CERTIFICATE OF APPROPRIATENESS

Property: 638 Heights Boulevard, Lot 22, Block 277, Houston Heights Subdivision. The property includes a historic 1,108 square foot, one-story wood frame single-family residence situated on a 7,500 square foot (50' x 150') interior lot.

Proposal: Alteration – Revision

NORTH SIDE ELEVATION

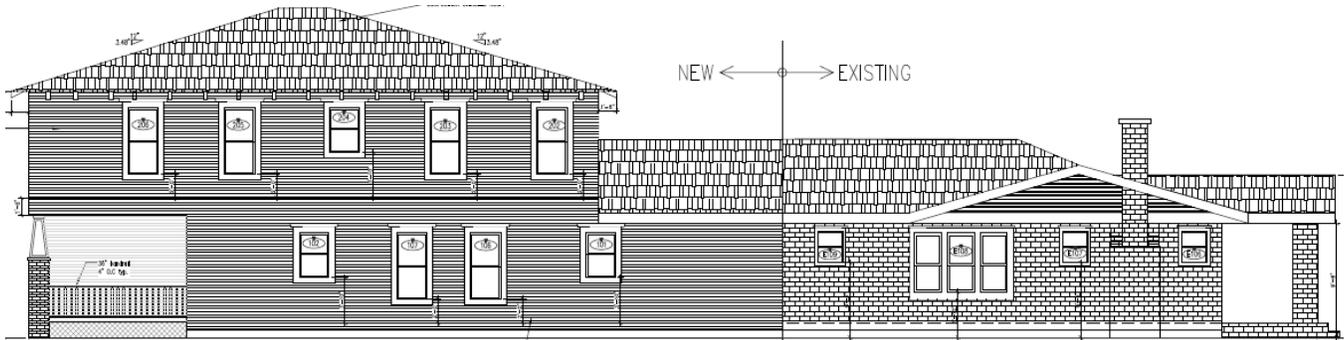
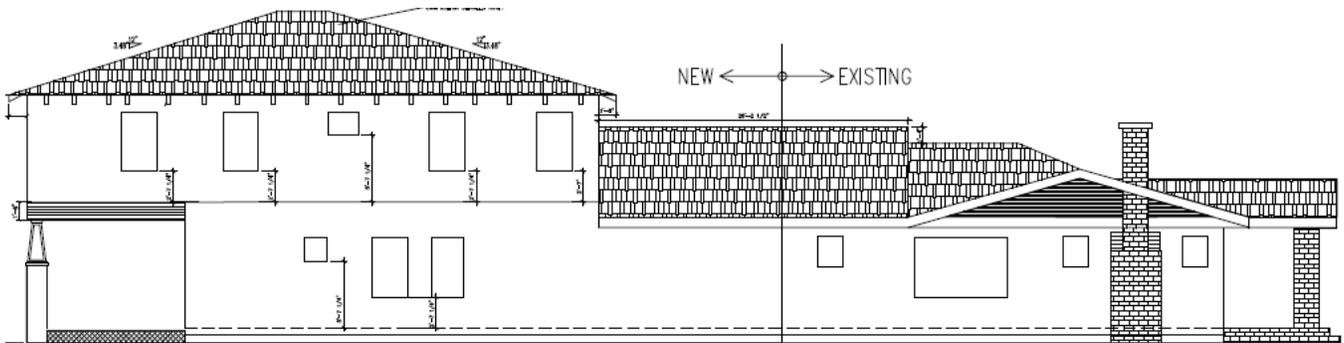
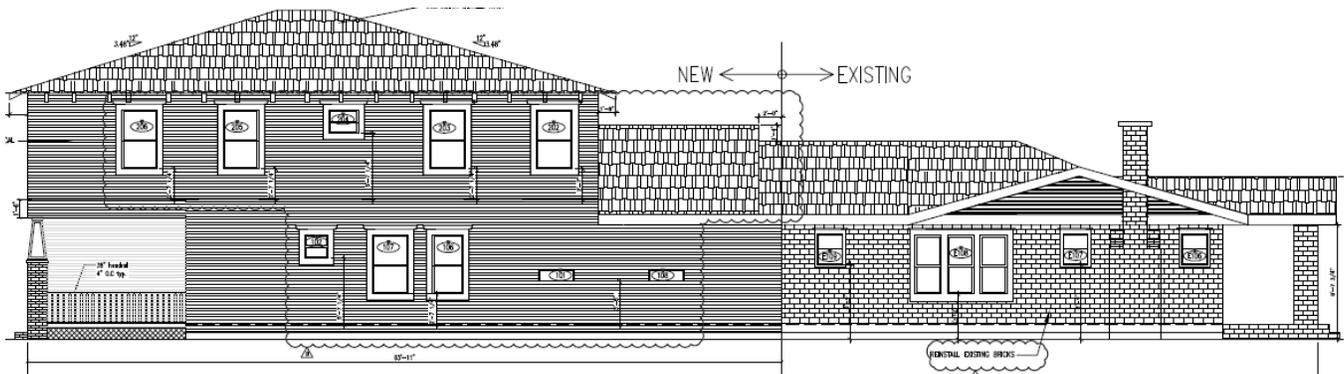
Side Elevation: The original house features six windows, all of which were removed and retained on site and will be repaired and reinstalled. The addition was approved to have three windows on the first floor and five windows on the second floor. The addition will feature two more windows on the first floor for a total of five.

SOUTH SIDE ELEVATION

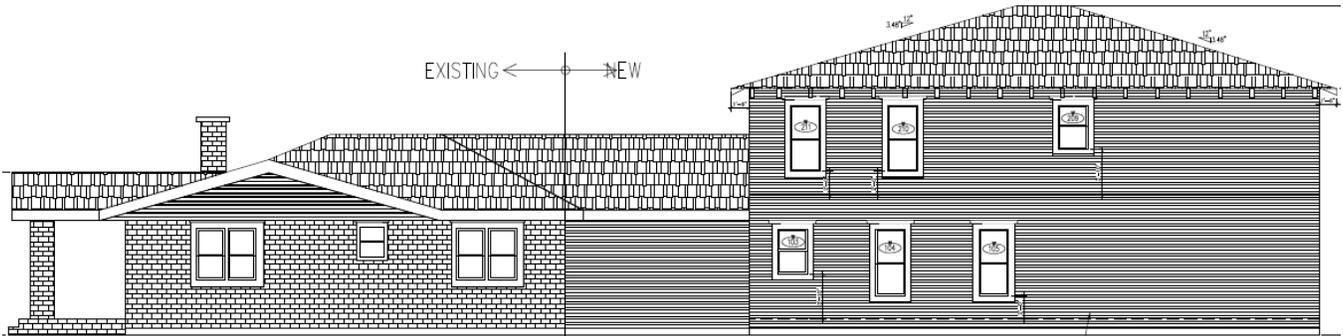
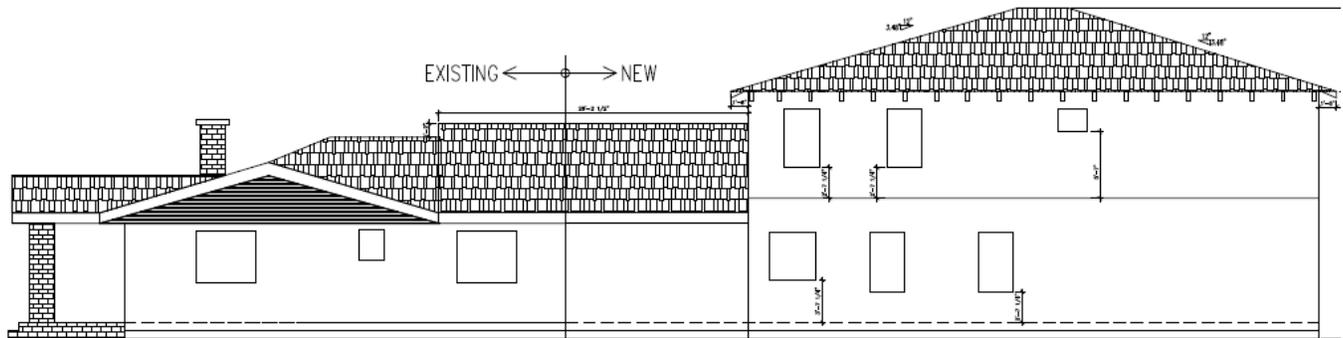
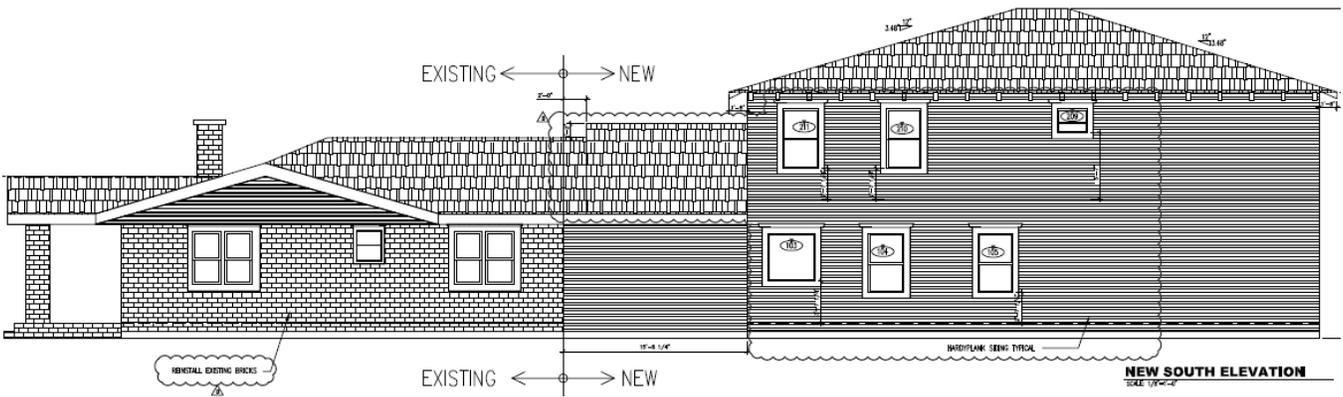
Side Elevation: The original house features two pairs of windows and a single window, of which one pair is still in place and will remain. The other windows were removed and retained on site and will be reinstalled. The addition was approved to have three windows on the first floor and three on the second floor. Their locations and sizes have been altered slightly.

ROOF PLAN

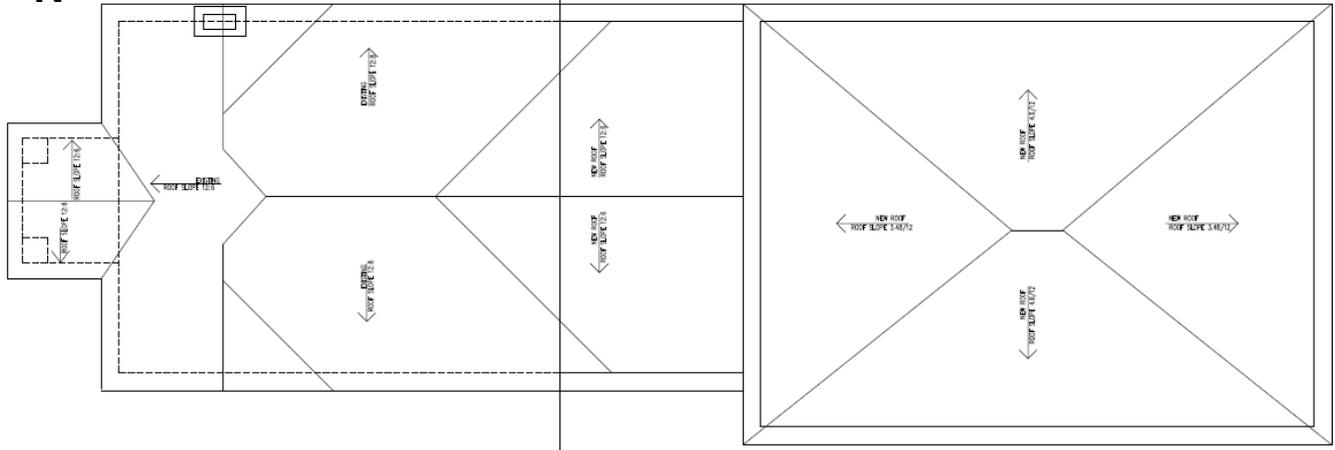
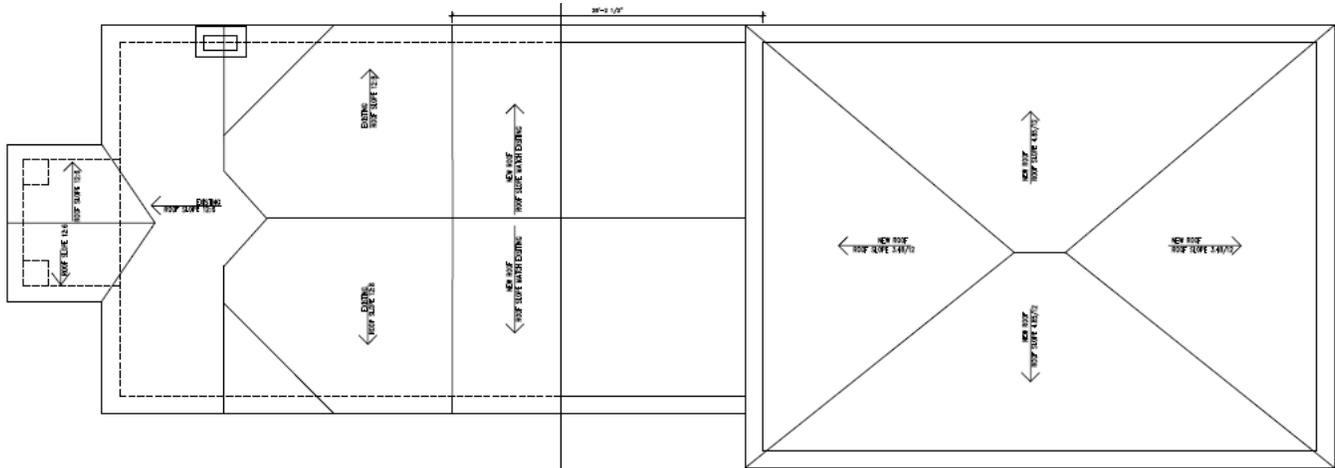
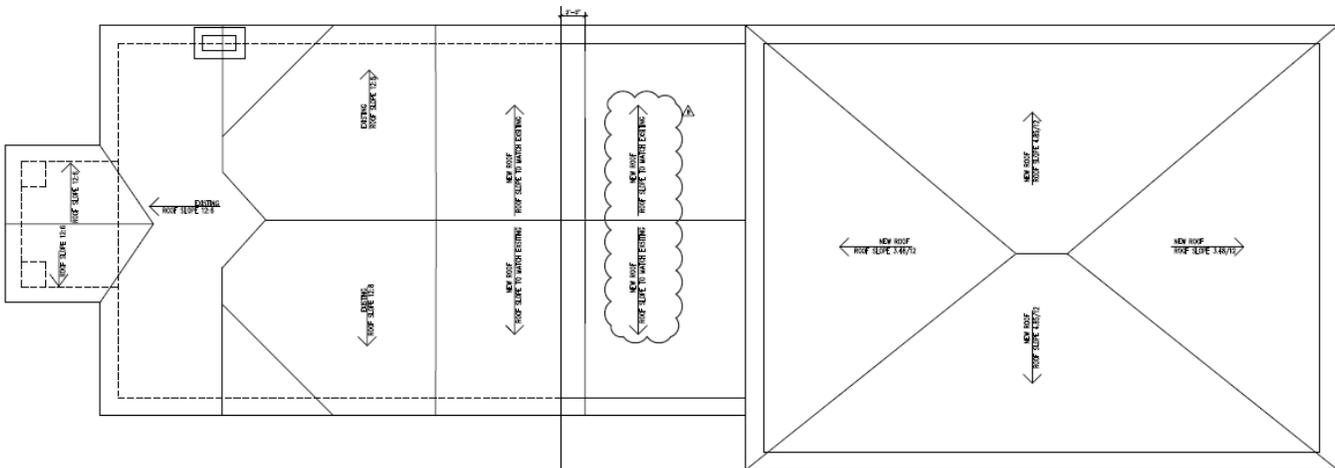
Roof: As part of the approved COA for the addition, the existing roof of the original structure was to remain. However, during construction, a portion of the original roof was removed and reconstructed at an increased height of 1'-2". The new unapproved roof encroached 10'-8" into the original structure.

The current roof, not built to plan, will be removed and replaced with a roof that matches the original height and configuration. The raised roof of the addition will now begin 1'-0" behind the original rear wall of the house on the north elevation and 4'-9" behind the original rear wall on the south. See drawings for more detail.
